NMP1L3070

March 18, 2016

Nine Mile Point Nuclear Station, Units 1 and 2
Renewed Facility Operating License Nos. DPR-63 and NPF-69
NRC Docket Nos. 50-220 and 50-410

Subject: License Amendment Request – Reactivity Anomalies Surveillance

3.1.2 Reactivity Anomalies

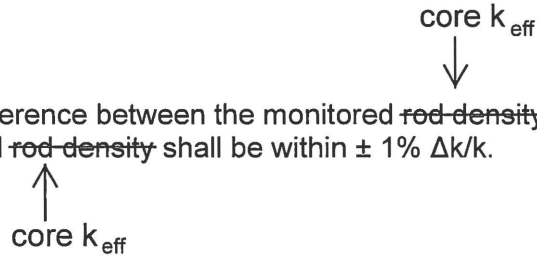
LCO 3.1.2 The reactivity difference between the monitored ~~rod density~~ and the predicted ~~rod density~~ shall be within $\pm 1\% \Delta k/k$.

SURVEILLANCE	FREQUENCY
<p>SR 3.1.2.1 Verify core reactivity difference between the monitored rod density and the predicted rod density is within $\pm 1\% \Delta k/k$.</p>  <p style="text-align: center;">core k_{eff}</p>	<p>Once within 24 hours after reaching equilibrium conditions following startup after fuel movement within the reactor pressure vessel or control rod replacement</p> <p><u>AND</u></p> <p>1000 MWD/T thereafter during operations in MODE 1</p>

SR 3.1.2.1

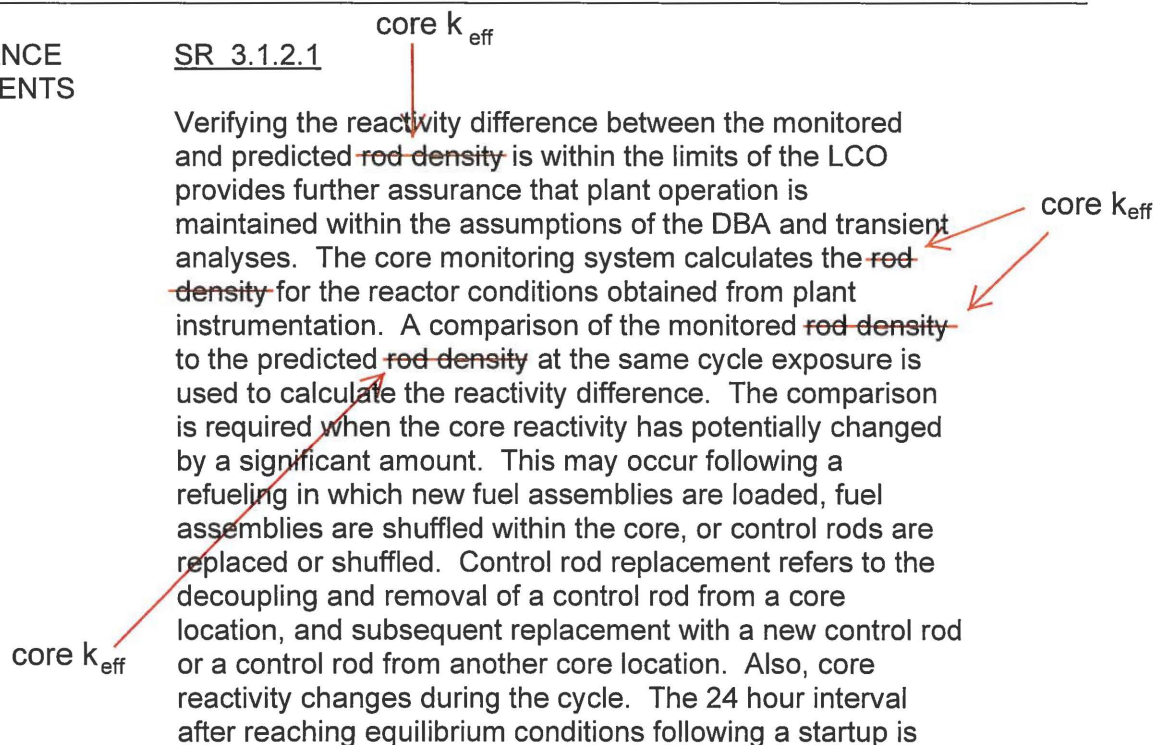
Verifying the reactivity difference between the monitored and predicted ~~rod density~~ is within the limits of the LCO provides further assurance that plant operation is maintained within the assumptions of the DBA and transient analyses. The core monitoring system calculates the ~~rod density~~ for the reactor conditions obtained from plant instrumentation. A comparison of the monitored ~~rod density~~ to the predicted ~~rod density~~ at the same cycle exposure is used to calculate the reactivity difference. The comparison is required when the core reactivity has potentially changed by a significant amount. This may occur following a refueling in which new fuel assemblies are loaded, fuel assemblies are shuffled within the core, or control rods are replaced or shuffled. Control rod replacement refers to the decoupling and removal of a control rod from a core location, and subsequent replacement with a new control rod or a control rod from another core location. Also, core reactivity changes during the cycle. The 24 hour interval after reaching equilibrium conditions following a startup is

based on the need for equilibrium xenon concentrations in the core, such that an accurate comparison between the monitored and predicted ~~rod density~~ values can be made. For the purposes of this SR, the reactor is assumed to be at equilibrium conditions when steady state operations (at equilibrium xenon with no control rod movement or core flow changes) at $\geq 75\%$ RTP have been obtained. The 1000 MWD/T Frequency was developed, considering the relatively slow change in core reactivity with exposure and operating experience related to variations in core reactivity. This comparison requires the core to be operating at power levels which minimize the uncertainties and measurement errors, in order to obtain meaningful results. Therefore, the comparison is only done when in MODE 1.
